September 4, 2014

Reference: Supplemental Review
Gravel Removal Permit and Installation of a Solar Field
Off of Long Pond Road
Kingstown Corporation
Plymouth, Massachusetts
Project No. 2079.74

Sight line on Camelot Drive viewed toward the west and Shops at Five Way

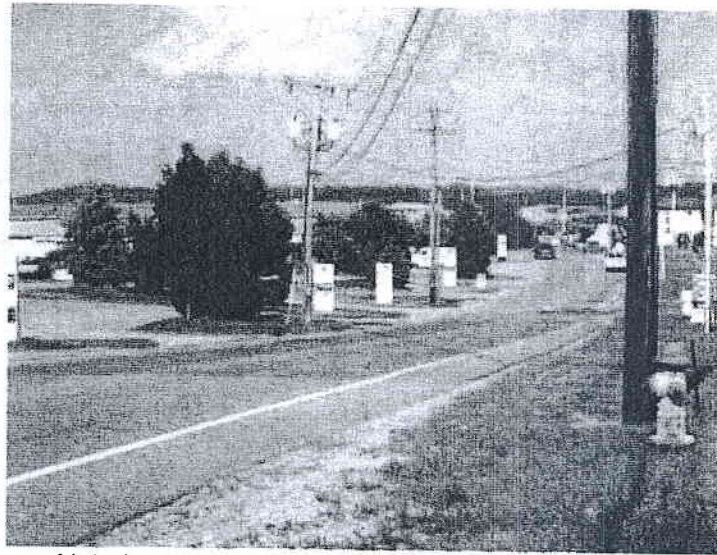
3. Documentation of both the stopping sight distance and the intersection sight distance should be provided by the Applicant. Appropriate signage may be required.

Current B+T Comment: We request the Applicant provide the required stopping and intersection sight distance for a basis of comparison (considering design speed, grade, etc.) to the 350+-feet provided as well as appropriate street signage be provided during the course of the earth removal operation.

Applicant's Response: Intersection sight distances and stopping sight distances are in excess of 350 feet in both directions. The proposed access point to Camelot Drive is the existing drive to Kingstown Trucking. The majority of trucks hauling material from the proposed project will be from Kingstown Trucking and therefore the intersection and stopping maneuvers have been tested for a sufficient period to be acceptable.

Existing cart path off the edge of the existing parking area

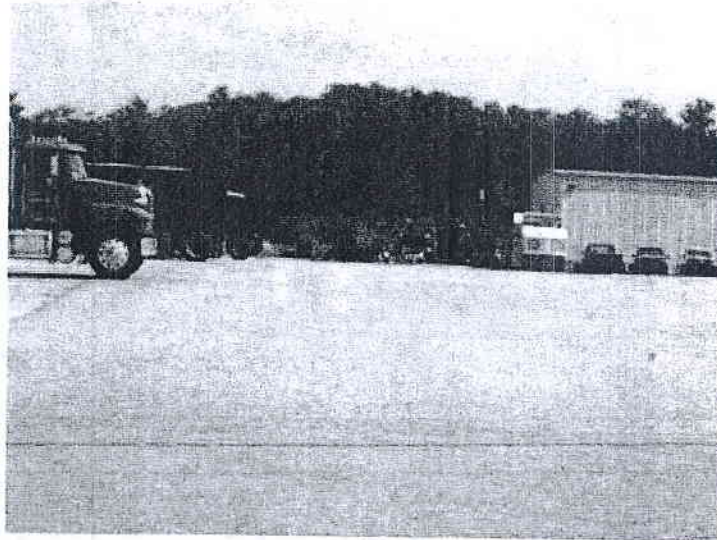
4. An appropriate stabilized construction entrance should be provided to reduce the tracking of sediment onto abutting properties and/or public ways.

Current B+T Comment: We consider this comment to be adequately addressed; however, the Applicant should still plan to implement measures to prevent the migration of sediment onto public ways during construction as necessary.

Applicant's Response: The paved surface through Kingstown Trucking is 250' long and will serve as the construction entrance.
